**Draft Cherrybrook Station Precinct Place Strategy, Cherrybrook Station State Significant Precinct government land rezoning proposal and amendment to the State Environmental Planning Policy (SEPP) Planning System**

**Subject: Cherrybrook Station Precinct - draft Cherrybrook Precinct Place Strategy, Planning Systems SEPP amendment and State Significant Rezoning Proposal**

**Cherrybrook Station State Significant Precinct government land rezoning proposal**

**Site Plan from Endeavour Energy's G/Net Master Facility Model.** Electricity infrastructure shown is the high voltage network (voltage of or over 11,000 volts / 11 kV).

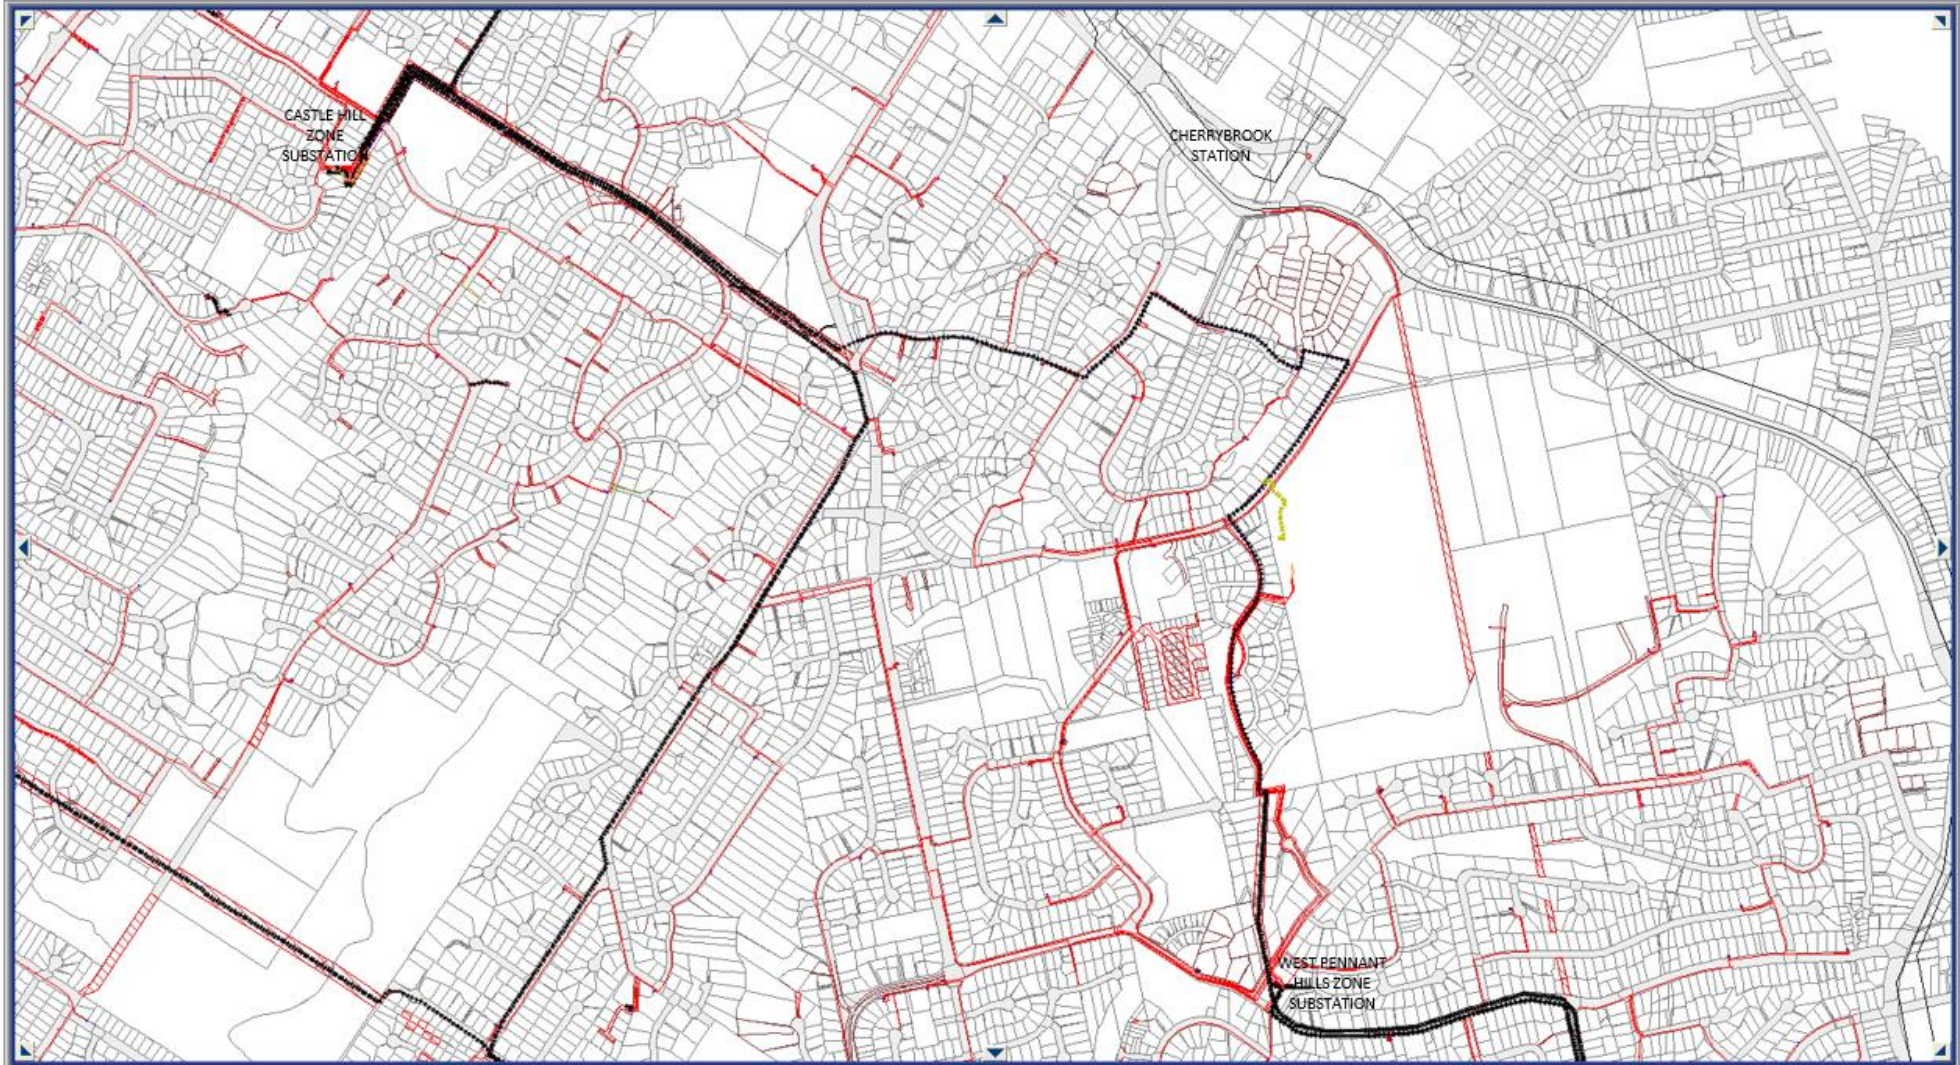
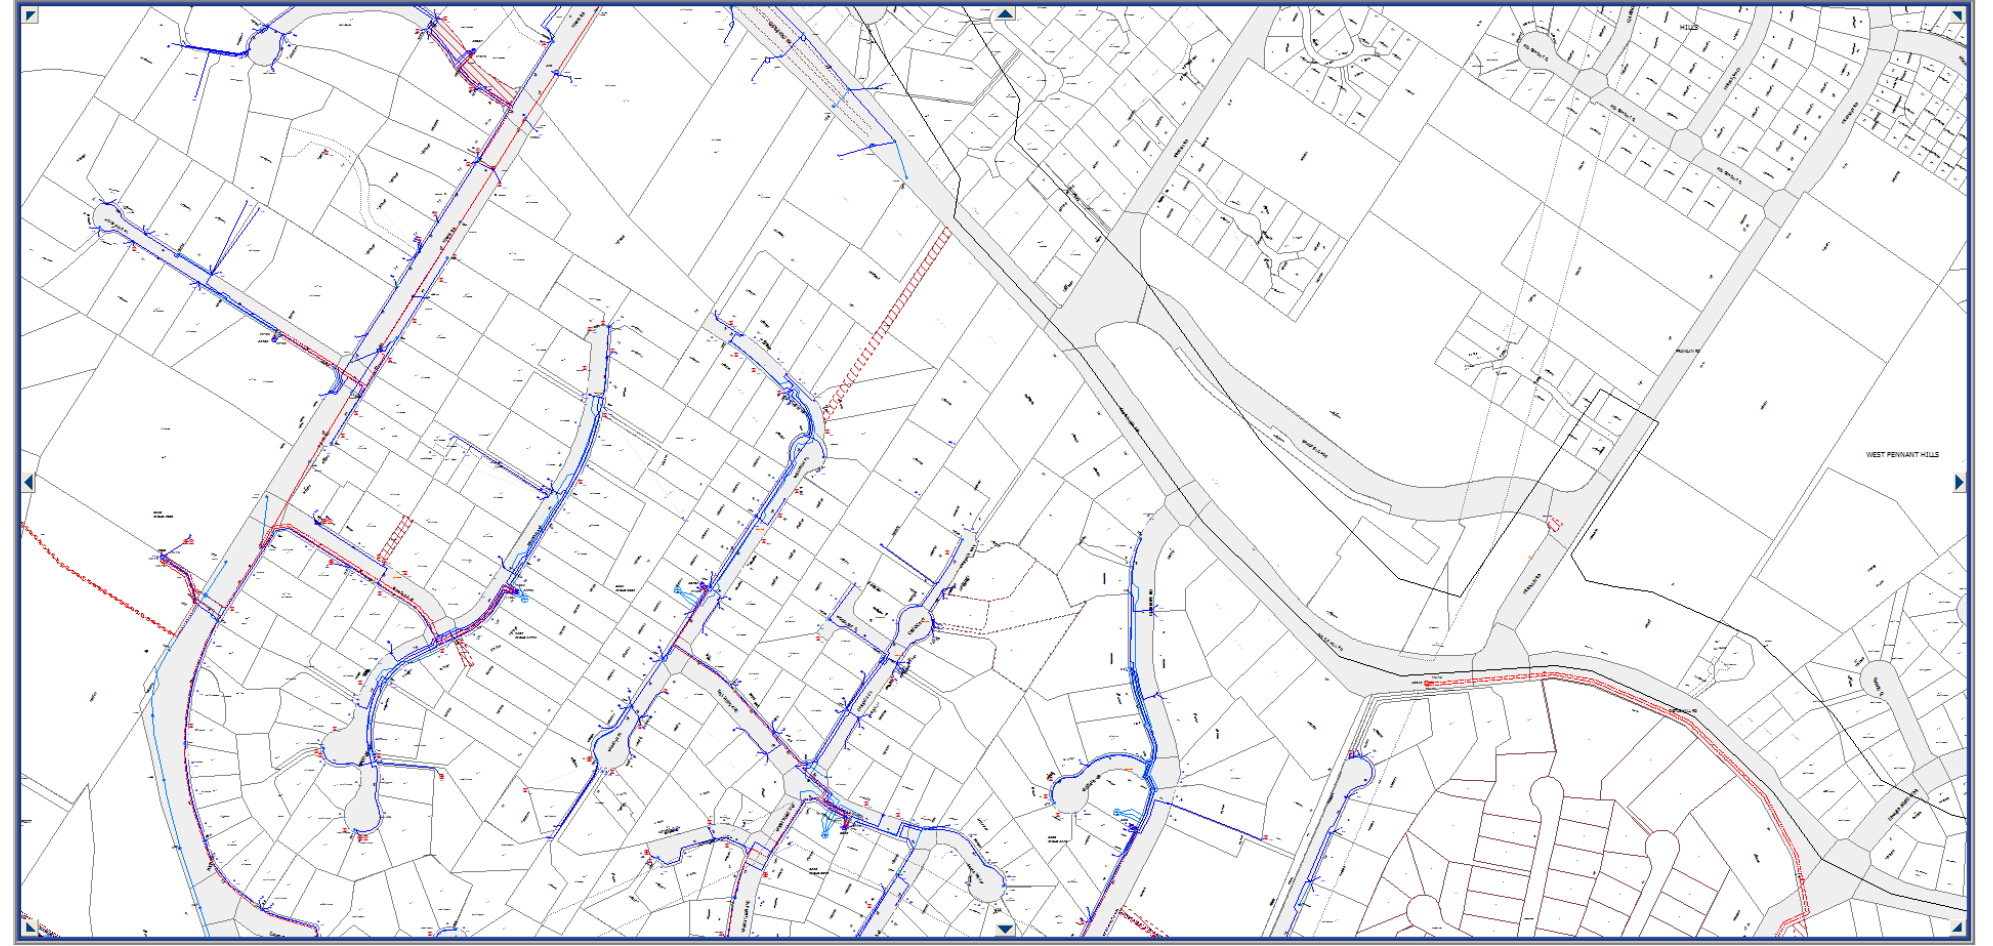
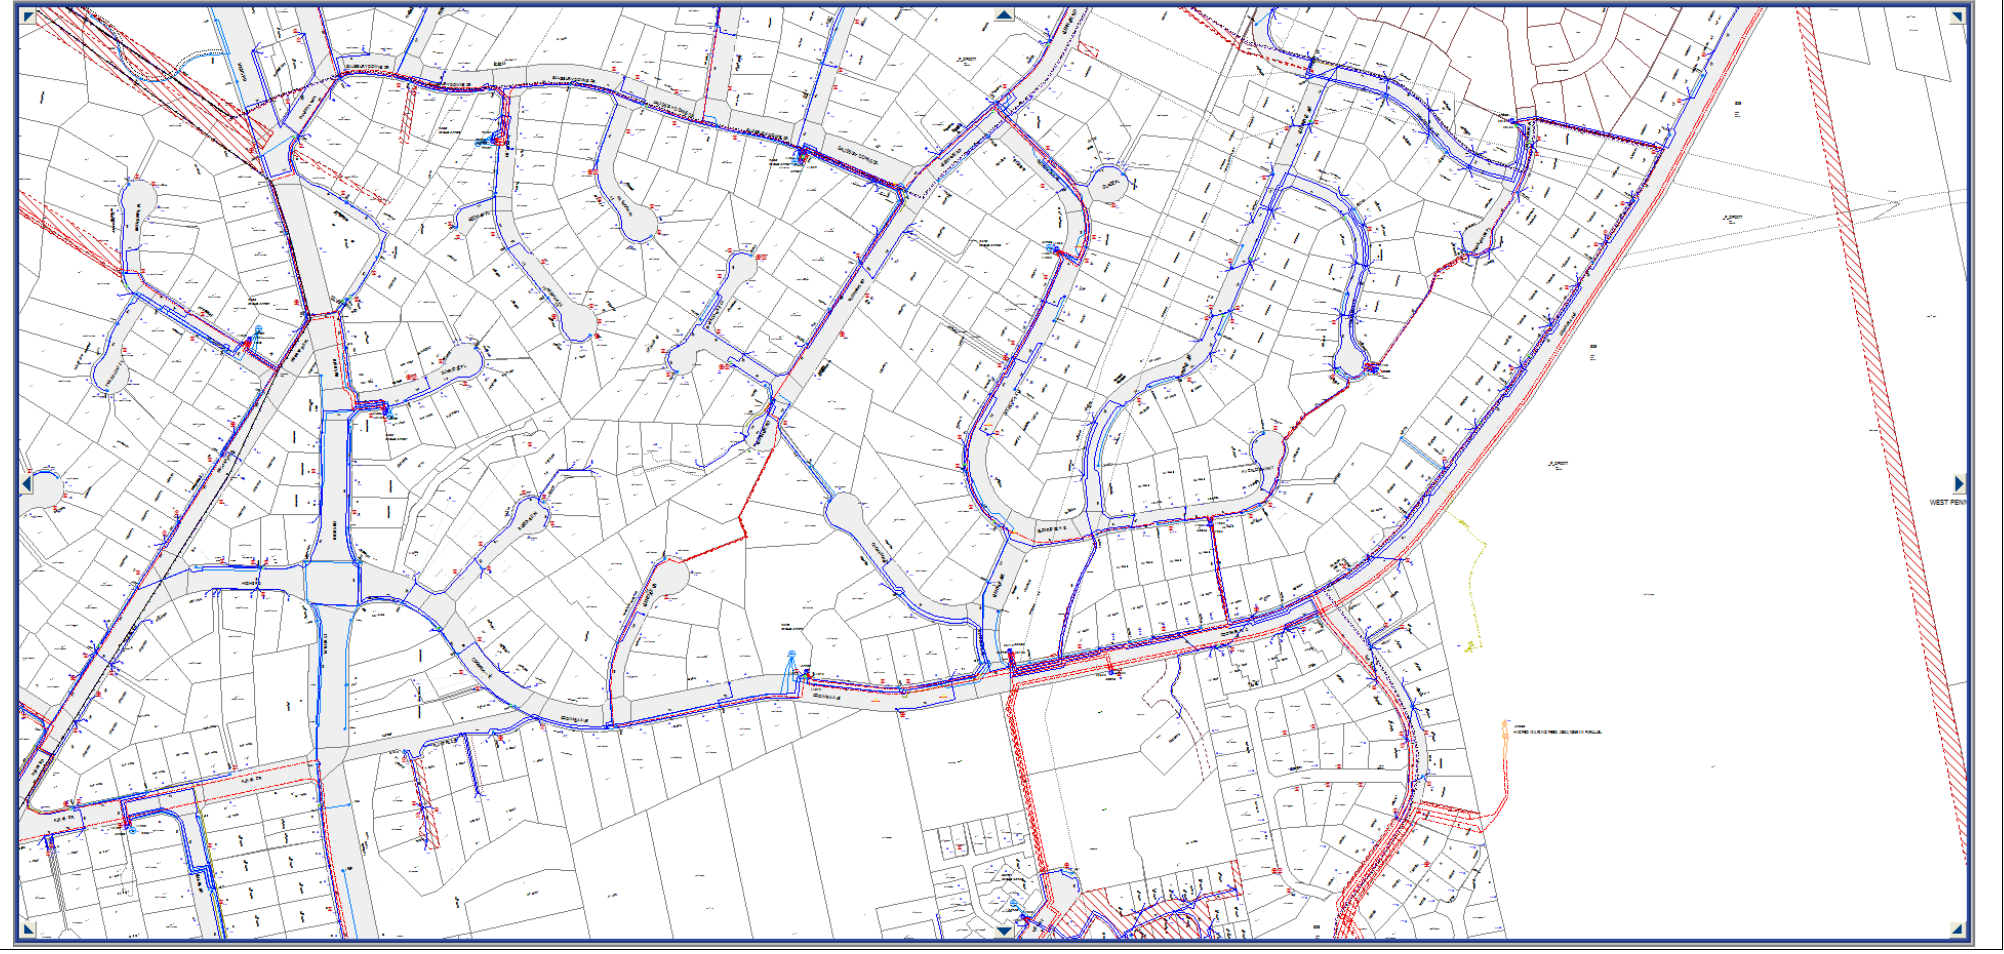
Due to the large area covered by the Cherrybrook Precinct, the scale required to show the area makes it difficult to see the detail in the plans. The plans show the area is predominantly serviced by underground cables with padmount substations with limited overhead power lines which and pole mounted substations. The Precinct is traversed by two 66,000 volt / 66 kilovolt (kV) high voltage feeders. However if the Department require more detailed plans of any specific area they can be provided upon request.
